Re: Keith Rosenthal
10 Creemer Road,
Section 108.02, Block 2, Lot 60

We are in receipt of the comment letters from Adam Kaufman, Kellard Sessions and the Westchester County Department of Health, for the Rosenthal project. Please find attached a copy of the Revised Plan Set in addition to a comment-by-comment response to each of the review items in your comment letters.

Kellard Sessions Review Memo September 26, 2022

EROSION AND SEDIMENT CONTROL PLAN

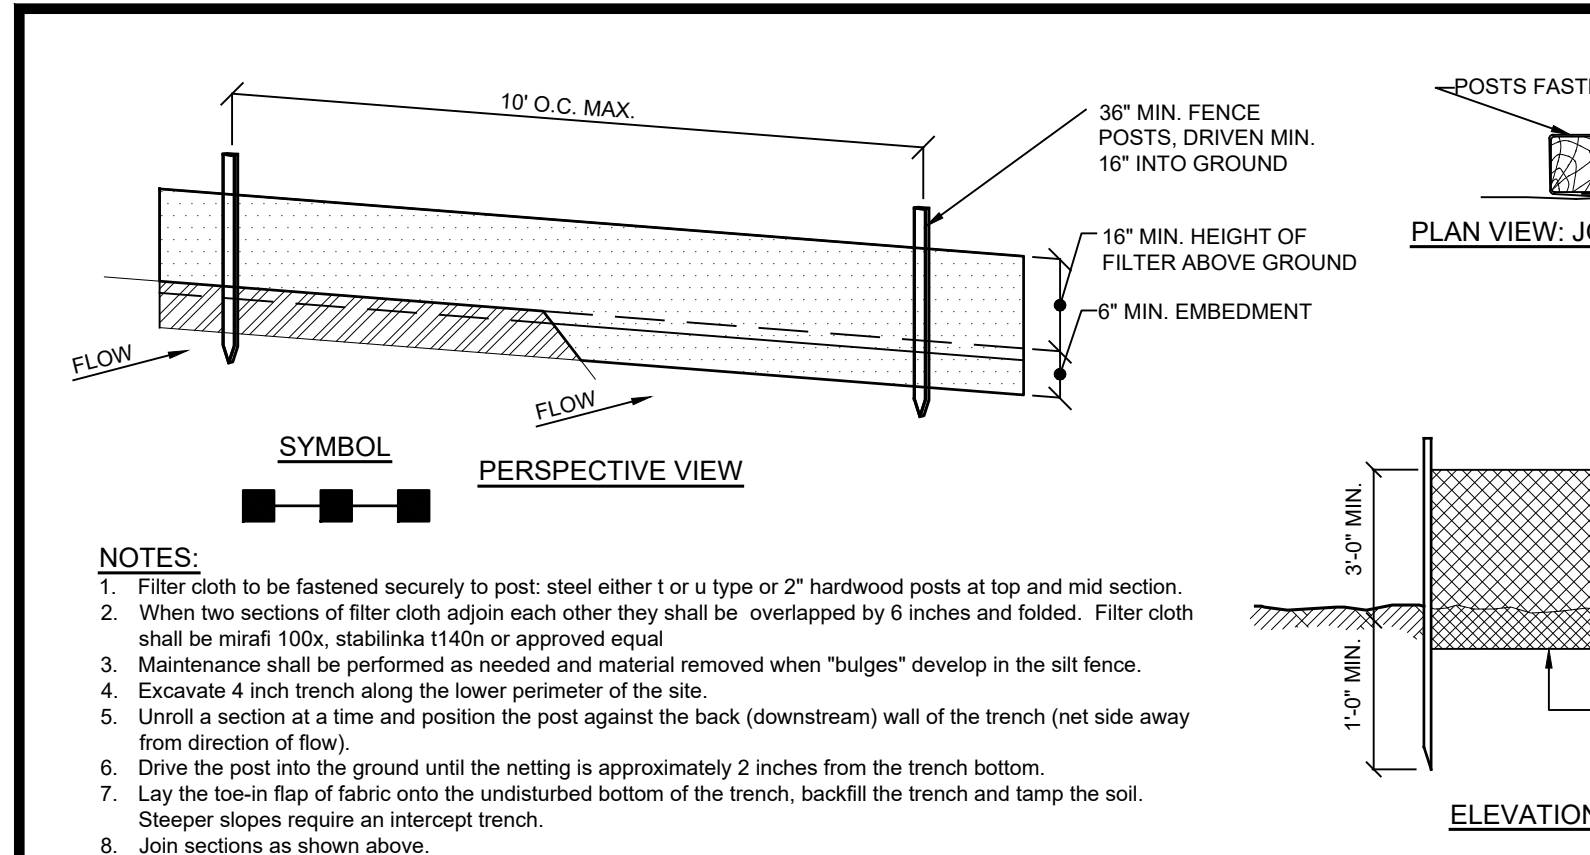
1. The wetland flags and intermittent watercourse were surveyed, and the survey was updated May 5, 2022, and confirmed by the Town Consultant May 25th, 2022. The Site Plan has been revised to reflect the updated wetland, buffer and intermittent watercourse.

SEPTIC SYSTEM 100% EXPANSION PROFILE DETAIL

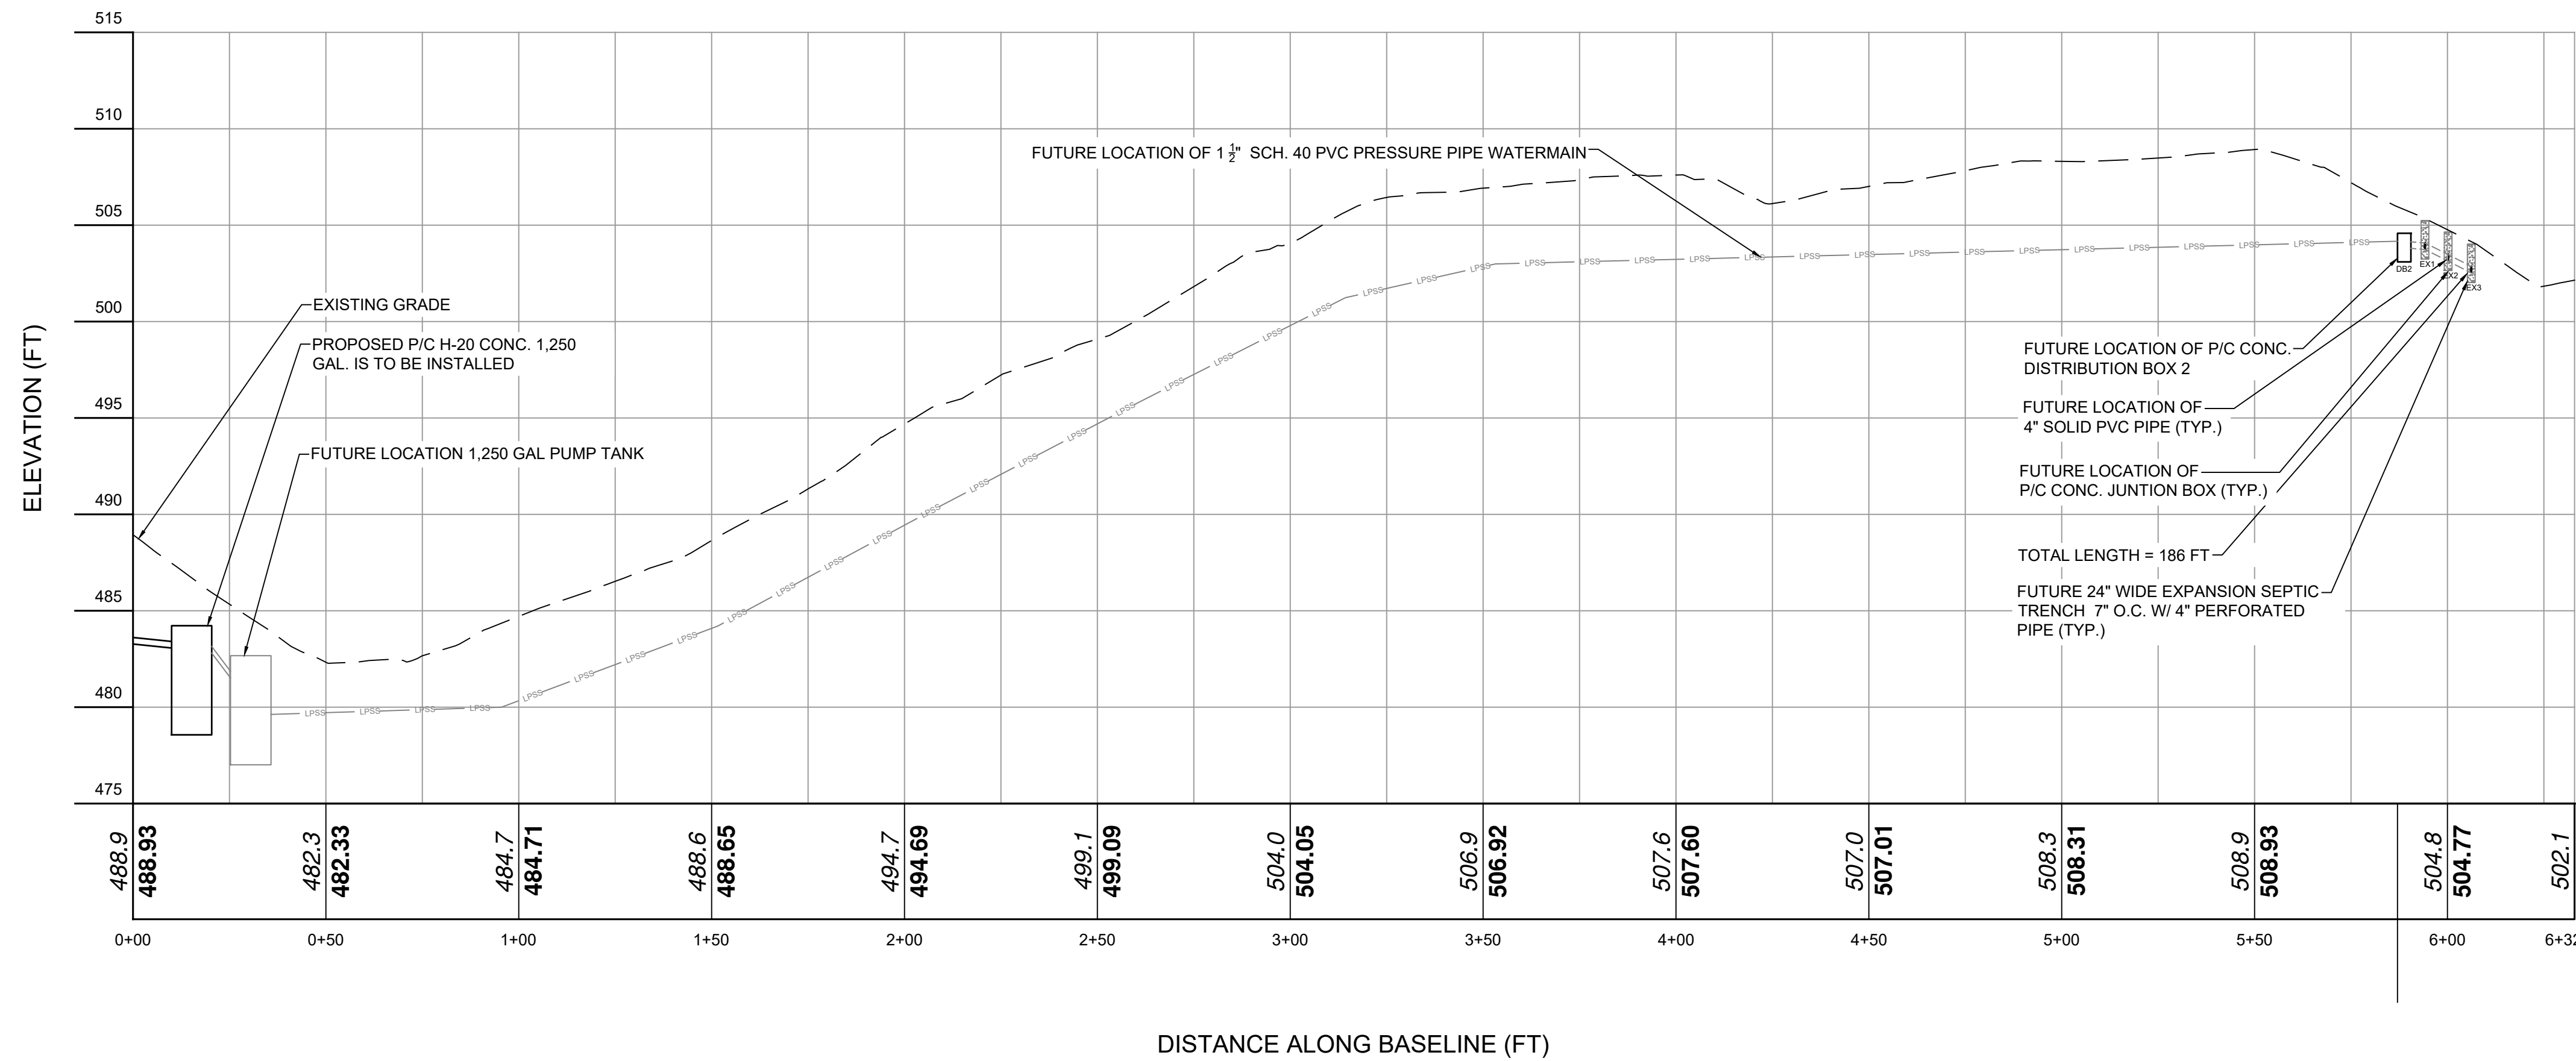
8. The septic profile has been revised.
9. There is no longer a note about 2' of R.O.B. of fill over the septic area. The note now states minor regrading. The WCHD has requested the slope of the septic area be provided as well as the distance to the driveway.
